L-2002-196  
10 CFR 50.90

RE: St. Lucie Unit 2  
Docket No. 50-389  
Proposed License Amendment  
Reduce the Minimum Reactor Coolant System Flow

### **ST. LUCIE UNIT 2 MARKED-UP TECHNICAL SPECIFICATION PAGES**

### **ST. LUCIE UNIT 2 MARKED-UP TECHNICAL SPECIFICATION BASES PAGES**

FIGURE B 2.1-1  
AXIAL POWER DISTRIBUTIONS FOR THERMAL MARGIN SAFETY LIMITS

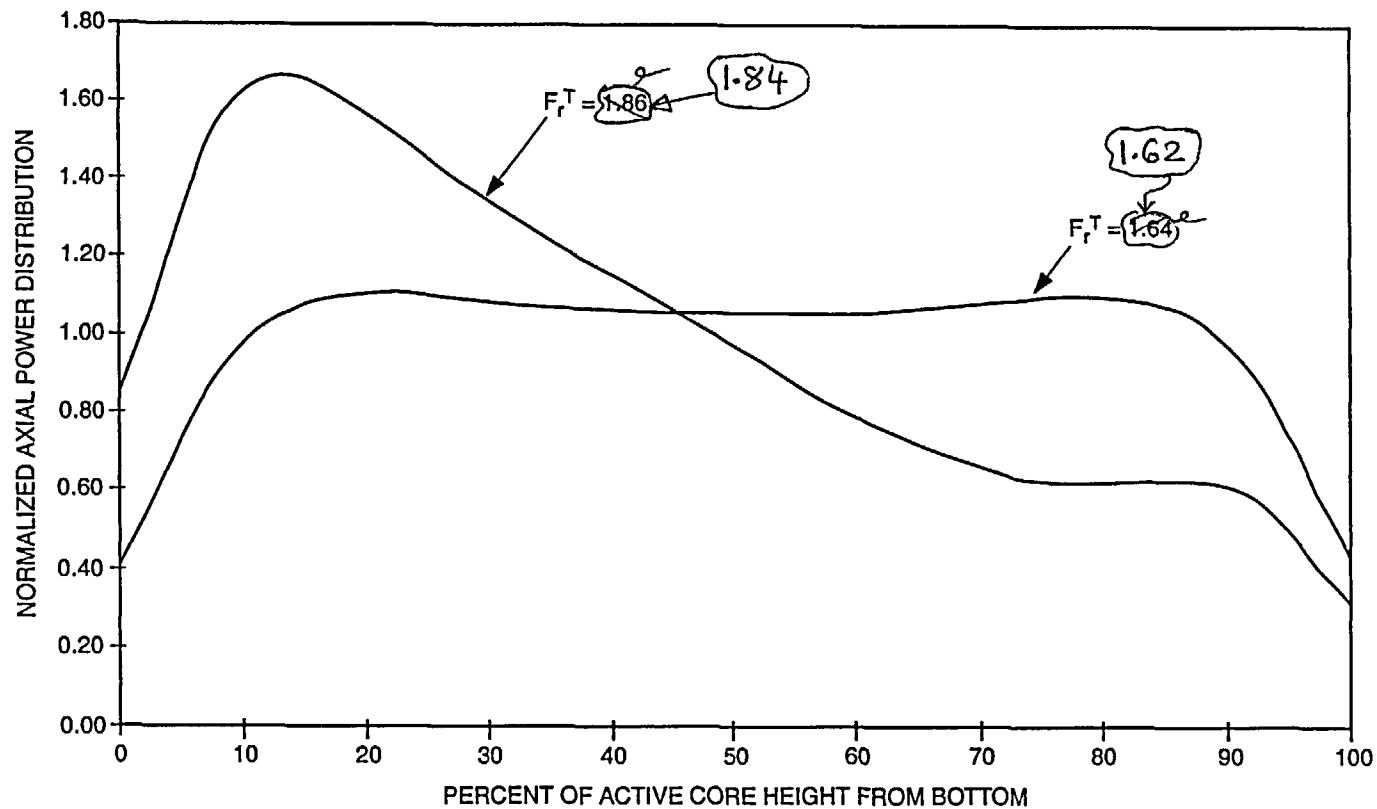
The basis Figure B2.1-1 is revised to include the effects of the proposed reduction in reactor coolant system design flow rate to 355,000 gpm, so that the conditions specified in the basis continue to remain valid for the thermal margin safety limit lines (TMSLL) of TS Figure 2.1-1 for the case of reduced RCS flow. Also, the wording "DNB-SAFDL of 1.28" is replaced with "appropriate correlation limit for DNB-SAFDL."

The basis Figure B2.1-1 defines the axial shapes and radial peaks, which along with thermal power, RCS pressure, RCS flow, inlet temperature and DNB correlation, determine the curves of TS Figure 2.1-1 for which DNB-SAFDL is not violated. Revised radial peak values for this figure were calculated to reflect the decreased margin associated with the proposed reduction in the RCS flow from 363,000 gpm to 355,000 gpm. Consistent with the TS basis, Limiting Conditions of Operation (LCO) and reactor protection system (RPS) trips are verified to provide adequate protection against DNB and fuel centerline melt SAFDLs during normal operation and design basis anticipated operational occurrences to ensure that reactor core safety limits are satisfied.

In addition, the Technical Specifications Bases (Figure B 2.1-1) for St. Lucie Unit 2 Thermal Margin Safety Limit Lines (Technical Specification Figure 2.1-1) were reviewed and revised Fr values were calculated that reflect the decreased margin associated with a reduction in the minimum guaranteed reactor coolant flow rate from 363,000 gpm to 355,000 gpm.

appropriate correlation limit for DNB-SAFDL
